Re: Site Plan Approval
9197 Highland Rd.

The following comments address the latest review letters we received, as well as, the discussion we had with your team on June 9, 2026 regarding the above addressed project that is in for Site Plan Approval. Our client is proposing to renovate the exterior of the existing 5,506 sf building that was previously approved many years ago by your community as a two tenant use with 2 drive thru's. The site as designed & constructed will remain with minor curb revisions to accommodate a new canopy on the east side of the building. The building footprint and site design shall not be altered other than the two areas indicated on our plans. Our responses below are to address and/or clarify the review comments we received. The responses below follow the reviewing agency comments numerically.

WHITE LAKE RETAIL BUILDING

PROPOSED SITE AND BUILDING IMPROVEMENTS

SHEET NO.
A5-3

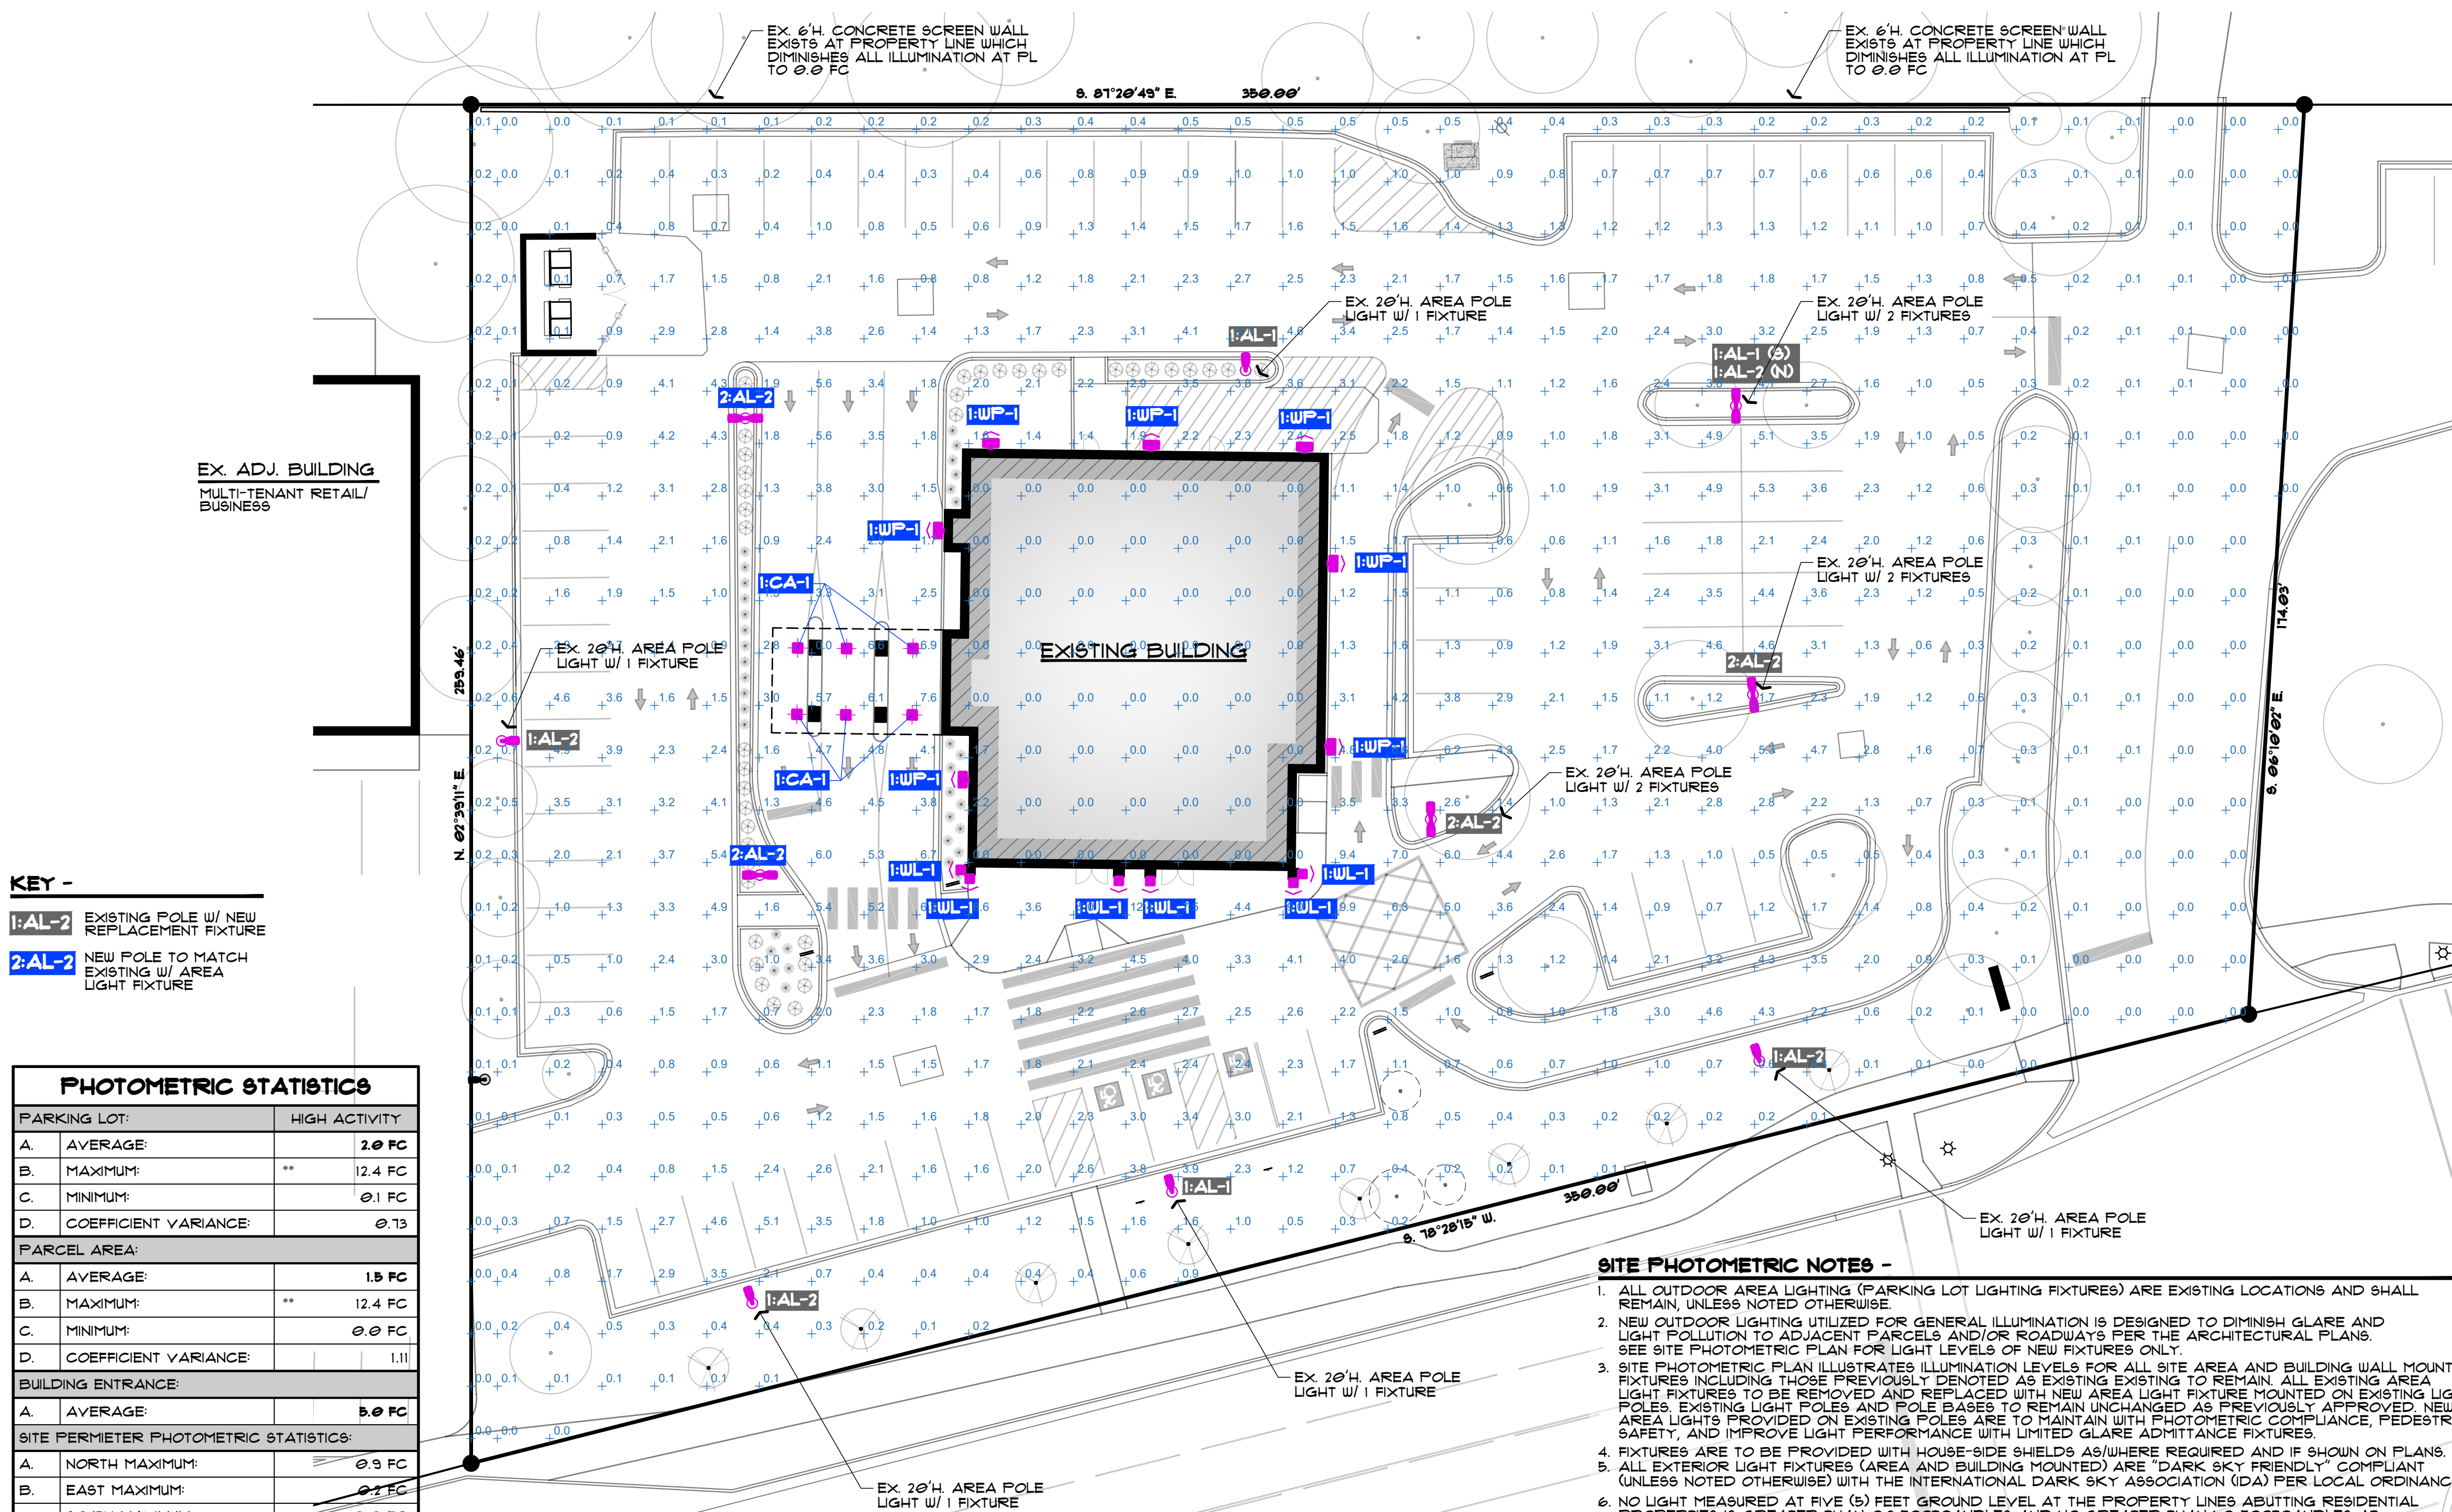
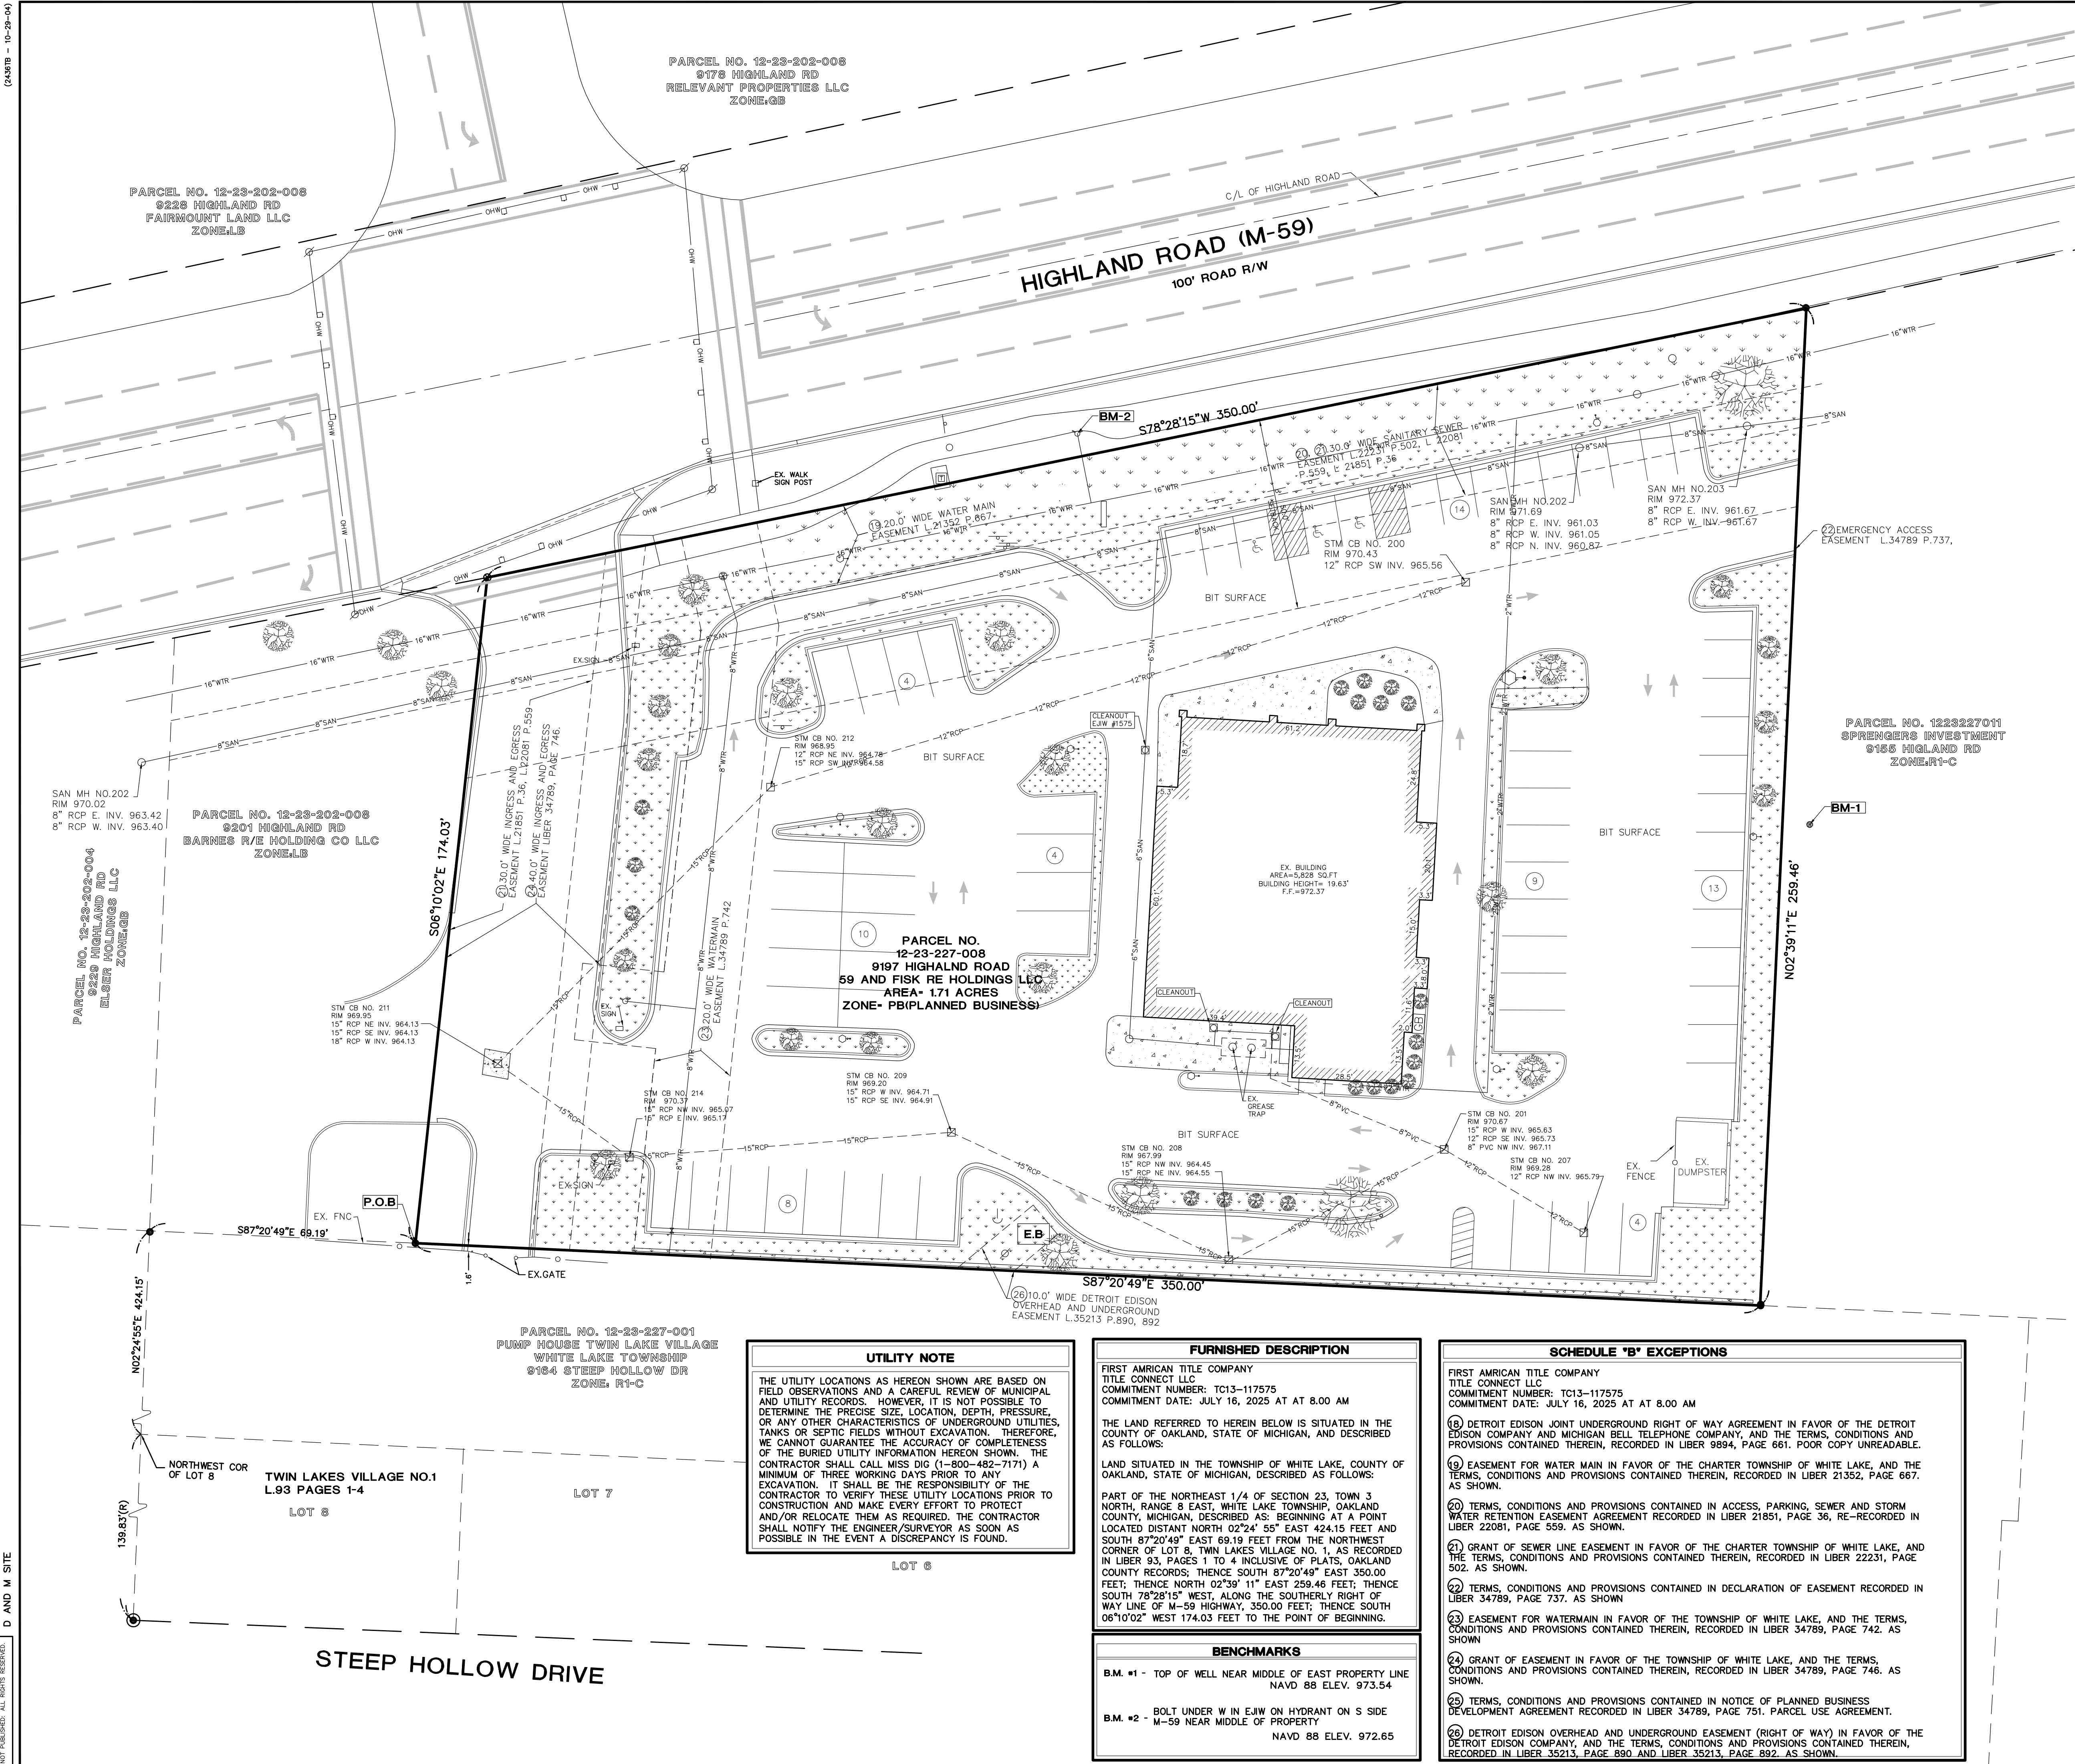
10. Site footcandle averages should be added to the plan per Section 5.18.G.viii.
Our plan Sheet AS-3 shows the Photometric Plan.
11. Footcandle measurements at residential lot lines and existing pole height do not meet.....
The existing site pole lights, location and heights are to remain unchanged. The two new light poles we are providing east of the New Canopy shall meet the ordinance and be 20' high. We do meet the requirements for fc levels per the ordinance at adjacent property lines. See AS-3.
